From: Hargrave, Morgan [Morgan.Hargrave@ghd.com]
Sent: Tuesday, June 14, 2016 10:54 AM
To: Detterman, Mark, Env. Health
Cc: Horne, Mark (MarkHorne)
Subject: RE: ACEH Correspondence for RO137 (Chevron 90019, 210 Grand Ave, Oakland) - Outfall Sampling Issues
Attachments: 90019-BRIDGE.JPG; 90019-SORMWATER DISCHARGE POINT.pdf

From: Detterman, Mark, Env. Health [mailto:Mark.Detterman@acgov.org]
Sent: Tuesday, June 14, 2016 9:53 AM
To: Hargrave, Morgan
Cc: Horne, Mark (MarkHorne)
Subject: RE: ACEH Correspondence for RO137 (Chevron 90019, 210 Grand Ave, Oakland) - Outfall Sampling Issues

STORMWATER
 DISCHARGE
 SAMPLE POINT -
 30" PIPE EMPTIES
 INTO CREEK
 BENEATH BRIDGE

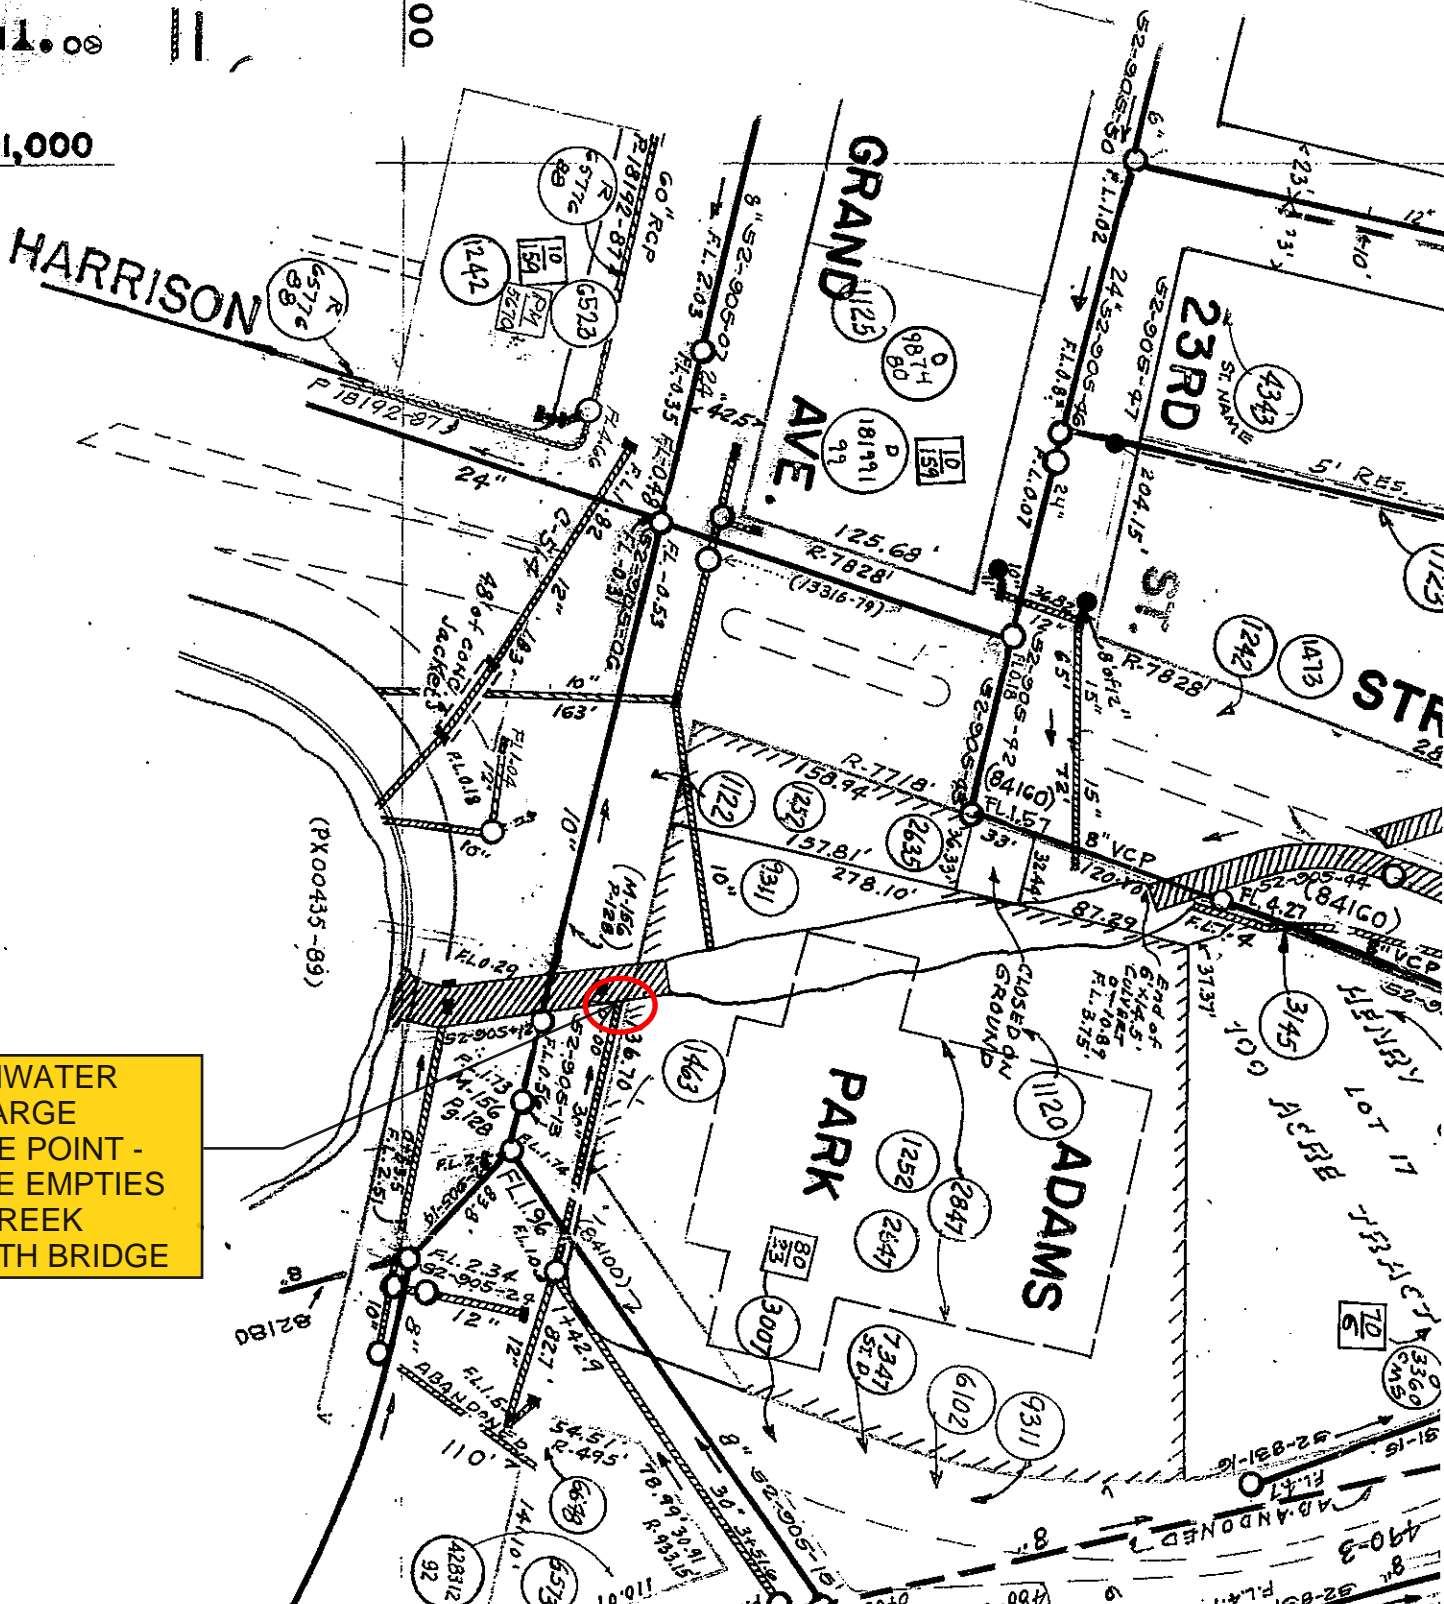
Sorry about that; you're correct. I spoke to our field rep and we got our wires crossed a little bit. The 'outfall' photo is a picture of the only line she could identify emptying into the creek. She said she could not see where the storm water outfall empties into the creek under the bridge without actually getting into the creek. Attached are the storm water map marked up with the assumed sampling point and a photo showing the creek under the bridge.

I'm mostly open today, so am around if you want to identify a time. I took a look at the photos and the "outfall" photo is for a line on the west side of the creek, and not the east towards the site, so it would not suit the purpose of the sampling. Based on my recollection of the utility plans I would guess the outfall is located beneath the bridge that the road becomes above the creek, so access may be more complicated, and it may be that there is currently insufficient water. It may be seasonal flow, which may provide dilution, or concentration of potential contaminate concentrations.
